World Forum for Harmonization of Vehicle Regulations

Working Party on Pollution and Energy

Proposal for a new Supplement to the 01 series of amendments to Regulation No. 101 (CO₂ emissions/fuel consumption)

Submitted by the expert from the International Organization of Motor Vehicle Manufacturers*

Figure 1
NEDC test cycle ~~Text sequence~~

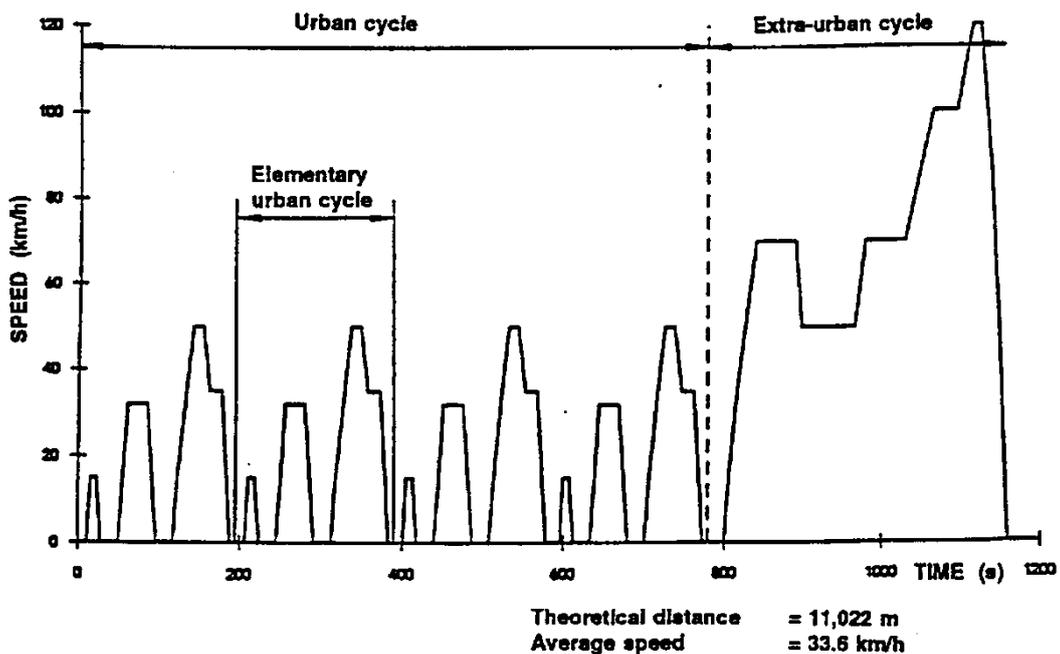
Annex 7, renumber paragraphs 1. to 1.3. as 2. to 2.3. and amend to read:

The NEDC test cycle ~~test sequence~~ is composed of two parts (see Figure 1):
